Re: The Chestnut House, 16 Chestnut Avenue

Scope of Work + Letter of Justification

Supporting Diagrams 12-17-2018

CURRENT DRIVEWAY ENTRANCE

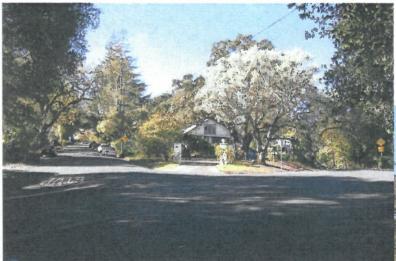
(Note: Easily visible as different from public roads)

CURRENT DRIVEWAY ENTRANCE

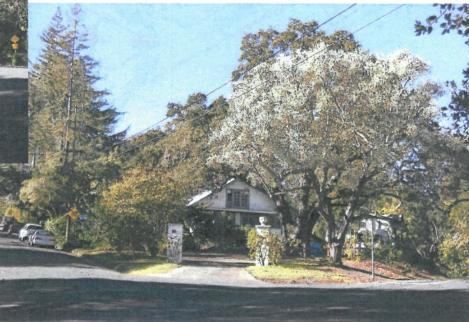
HISTORICAL COLUMNS DEFINE DRIVEWAY VISUALLY + CREATE SEPARATION FROM PUBLIC TRAFFIC PATTERN

NOTE, DRIVEWAY ENTRANCE IS PULLED AHEAD OF STOP SIGN WHICH ALLOWS FOR VISUAL CLEARANCE
